# ADDENDUM

Project: Fairmont, Liberty 3 Roof

Addendum No.: 1

Date: 14 Feb 2019

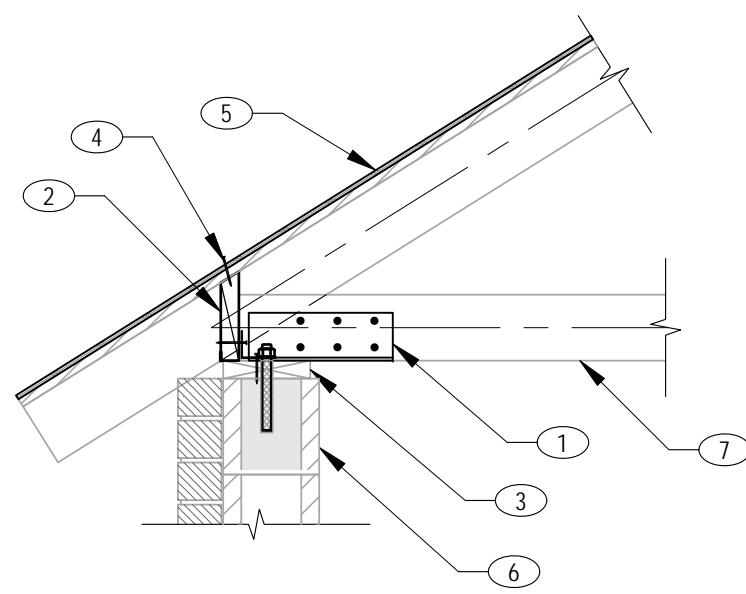
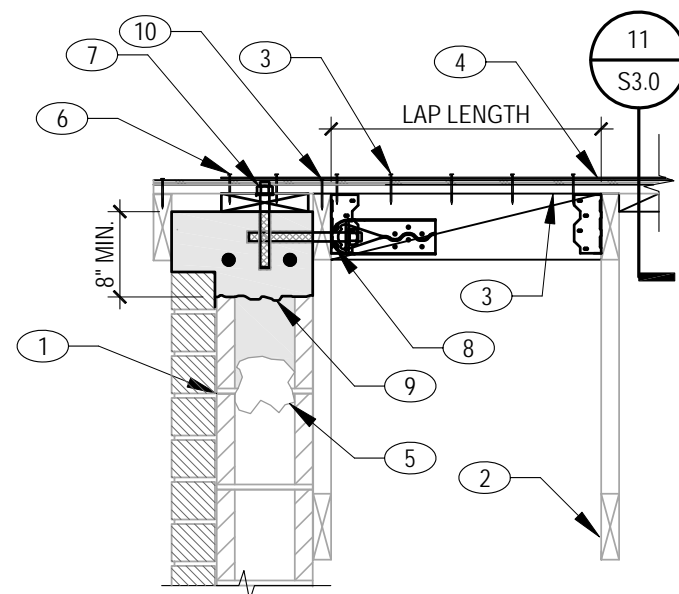
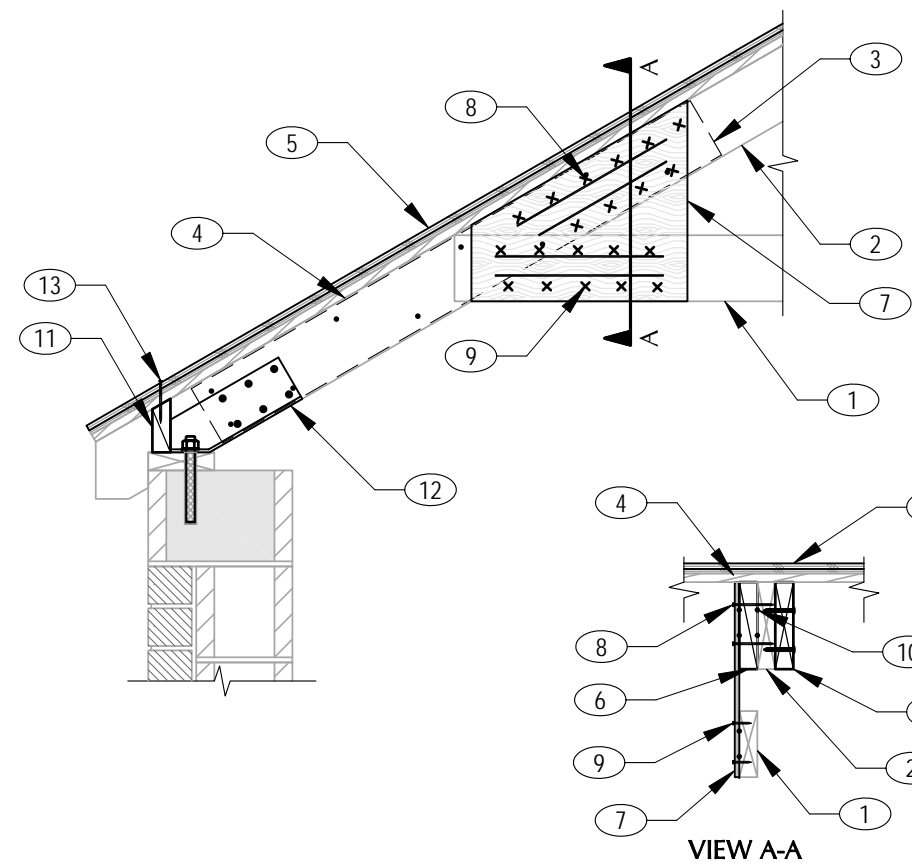
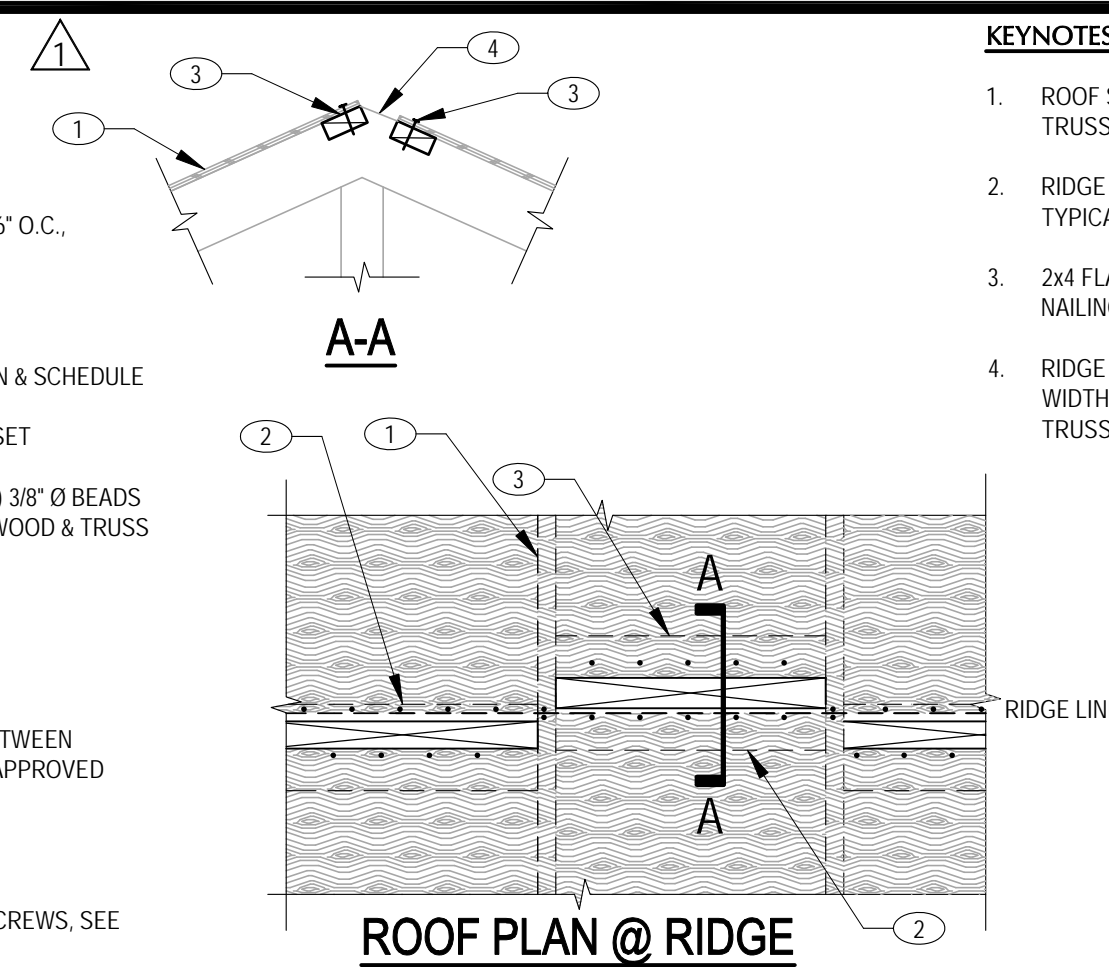
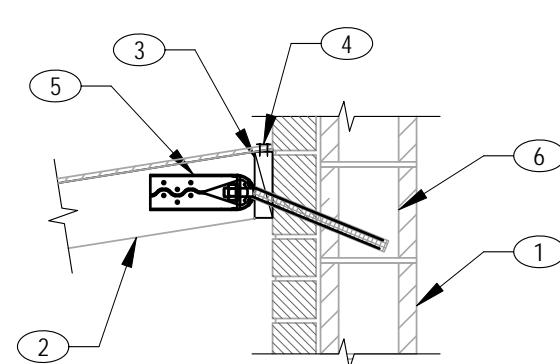
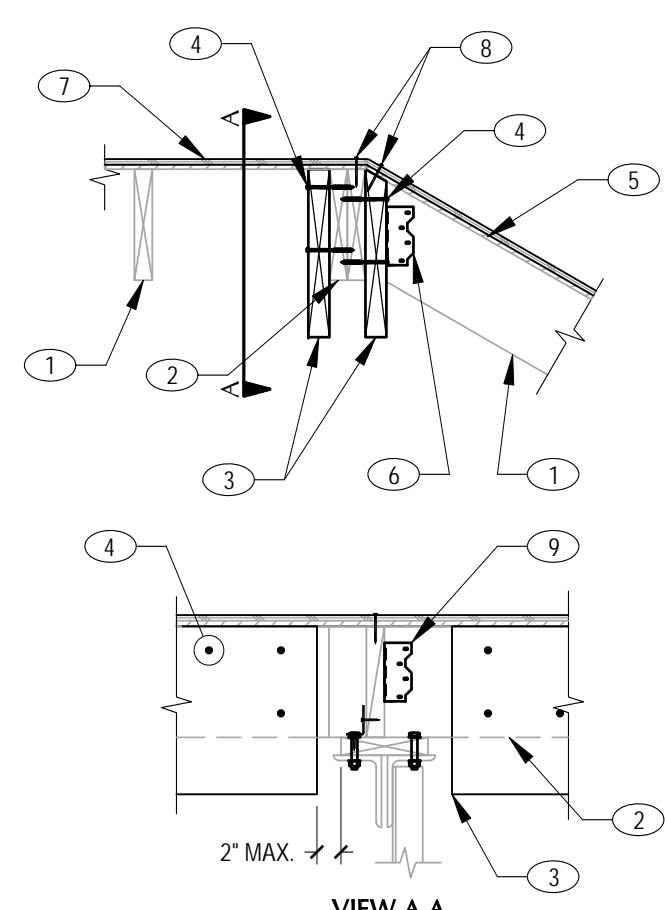
- a. Structural engineer has revised their detail sheet S3.0. Replace the sheet received at the pre-bid with that attached, revised sheet.
- b.
